Clearview Manor / Waterline Improvements

Project No. 6072370 6.2

ADDENDUM #1

ADDENDUM No. 1

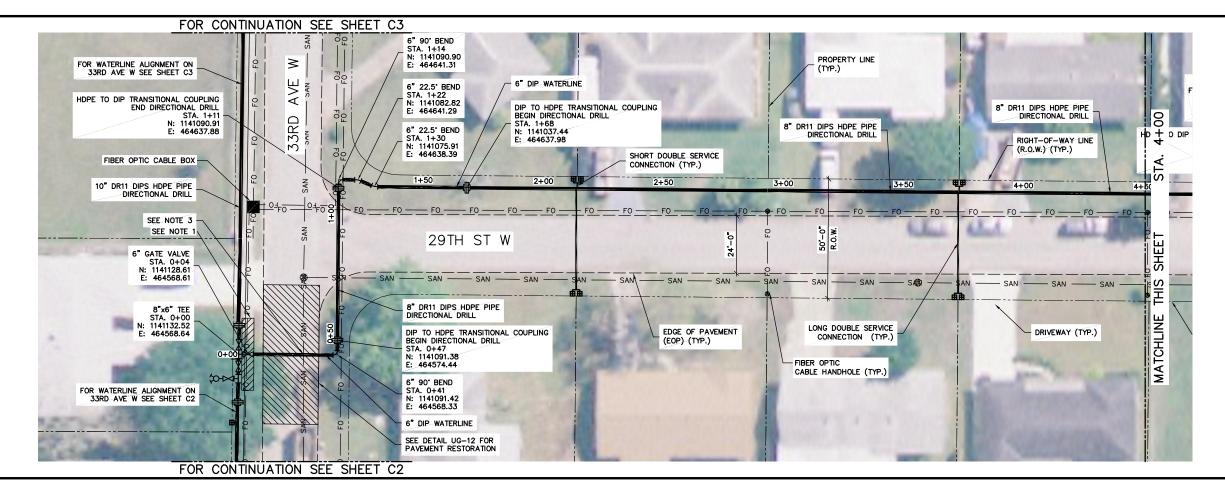
- 1. Drawing C-1, delete this drawing sheet and replace it with the attached drawing C-1, Revision 1. Changed diameter of directional drill from 10-inch to 8-inch diameter; changed valve and fitting sizes from 8-inch to 6-inch; added 8" by 6" reducer.
- 2. Drawing C-4, delete this drawing sheet and replace it with the attached drawing C-4, Revision 1. Changed diameter of directional drill from 10-inch to 8-inch diameter.
- 3. Drawing C-5, delete this drawing sheet and replace it with the attached drawing C-5, Revision 1. Changed diameter of directional drill from 10-inch to 8-inch diameter.
- 4. Drawing C-9, delete this drawing sheet and replace it with the attached drawing C-9, Revision 1. Changed 8-inch gate valve to 6-inch; revised note from transitional coupling to fire hydrant; eliminated 8" by 6" reducer.

SITE PLAN 29TH ST W SCALE: 1" = 20'

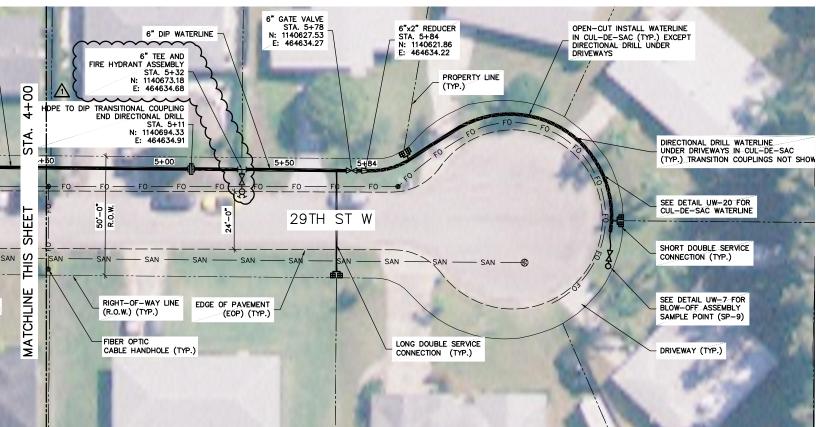
- 5. Drawing C-10, delete this drawing sheet and replace it with the attached drawing C-10, Revision 1. Relocated fire hydrant assembly.
- 6. Drawing C-11, delete this drawing sheet and replace it with the attached drawing C-11, Revision 1. Added 6" by 2" reducer.
- 7. Drawing C-12, delete this drawing sheet and replace it with the attached drawing C-12, Revision 1. Added 6" by 2" reducer.
- 8. Drawing CD-7, delete this drawing sheet and replace with the attached drawing CD-7, Revision 1. A detail for UW-12 ¾" & 1" Backflow Preventer, detail UW-13 1 ½" & 2" Meter and Backflow Preventer, and a new transitional coupling (for DIP to HDPE) have been added.
